# An Opportunity to Renew

This document has been put together to support a submission by R3 Residents

## AN OPPORTUNITY TO RENEW

## Connect Fishburn Crescent through to Showground Road

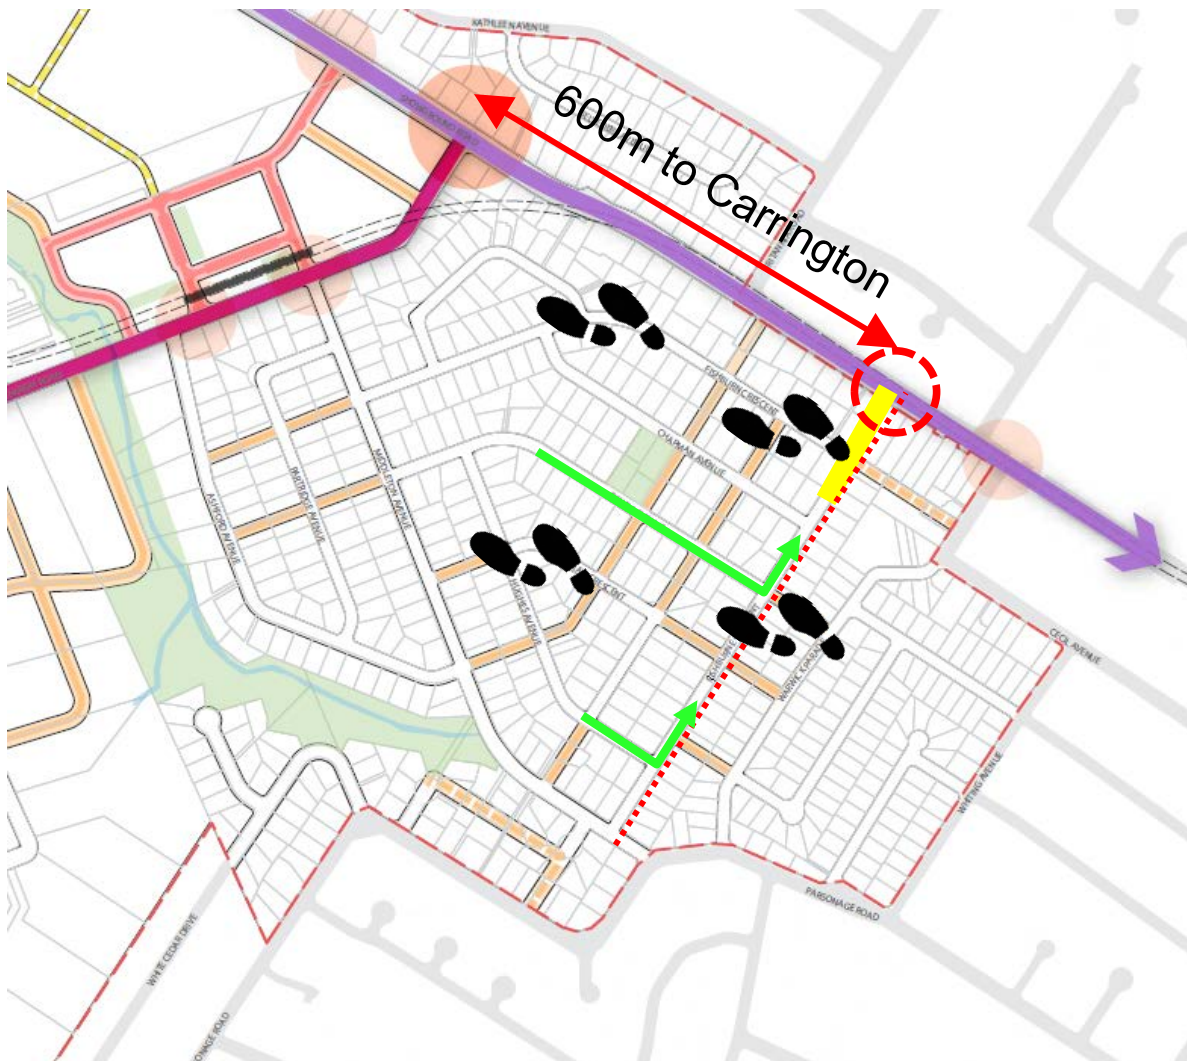
With extra dwellings in the precinct, it is imperative that access be provided to Showground Road in some way. The existing proposal is to extend Ashford and run a road right through to 52 and 54 Fishburn Crescent, down onto Showground Road.

We do not believe it is the preferred option for a number of reasons:

- It cuts the precinct in two, which means that opportunities like the large 2+ha park simply could not be built.
- It limits the opportunities to master plan and to provide flexible building areas.

Similarly shifting the Ashford extension to the west to align with Britannia Road might appear attractive but it would suffer from the problems just mentioned, and worse would introduce traffic into the precinct from the north.

It would be far better to have an appropriately designed intersection, connecting Fishburn Crescent to Showground Road ...

Fishburn Crescent would become a very **well defined precinct boundary, with traffic funnelled to the precinct edges**, keeping it out of areas best kept for people.

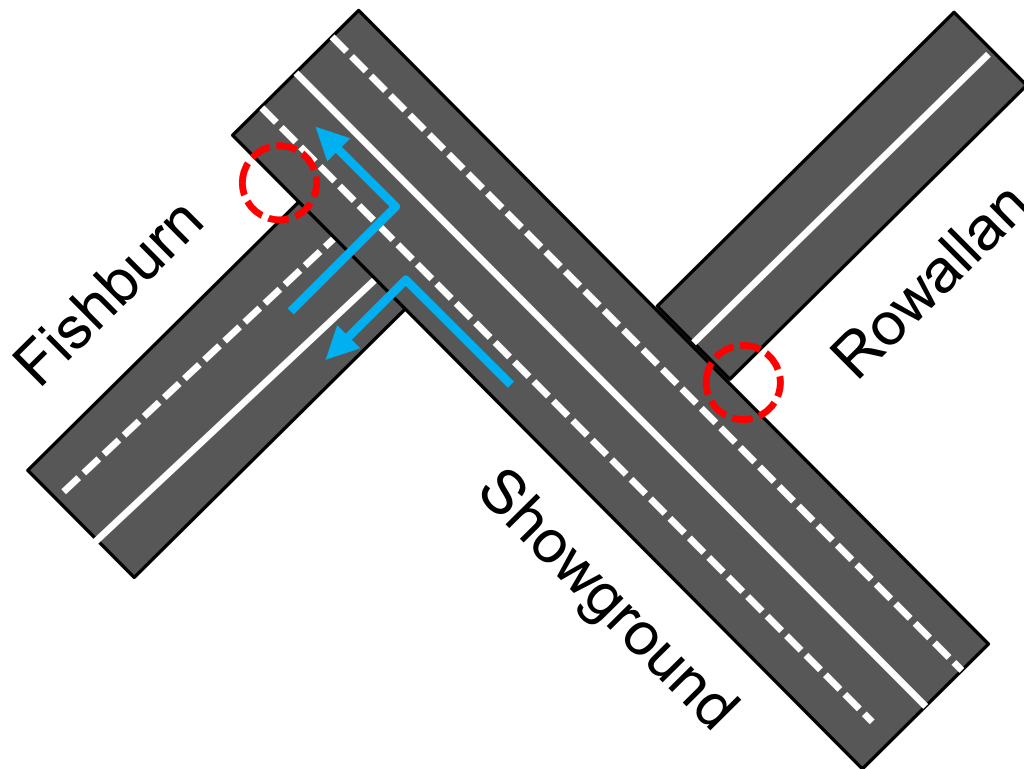
In addition the intersections of Showground Road with Rowallan and Fishburn could work well as follows:

The intersection with Rowallan is about 120 metres from the intersection with the proposed extension of Fishburn Crescent. Travelling at 60 kph, a vehicle will traverse that distance in just over seven seconds.

120 metres would also mean that almost the entire peak hour flow of cars from Rowallan could 'park up' in the space on Showground Road between Rowallan and Fishburn. They would wait for the right turn lights from Rowallan, turn onto Showground Road and then wait for the Fishburn lights to turn to green (while cars exiting Fishburn were getting onto Showground). If you are worried about having space between Rowallan and Fishburn, you could phase the Fishburn stop signal just 5-10 seconds after the Rowallan top signal – it would free up more than enough space. The volume of cars from Rowallan is miniscule in any event and the intersection should be designed around the Fishburn volumes which are likely to be greater at peak times.

We suggest that the following also ought to be considered in any design:

- Having dual lanes exiting the precinct, as you want minimal interruption to the Showground Road flow. You want cars from the precinct to get onto Showground in numbers and quickly once the lights go green.
- Allow for a small amount of widening of Fishburn up the hill to facilitate any queuing that might be needed for the lights. Having 80-90m of double lanes however should reduce this requirement somewhat.
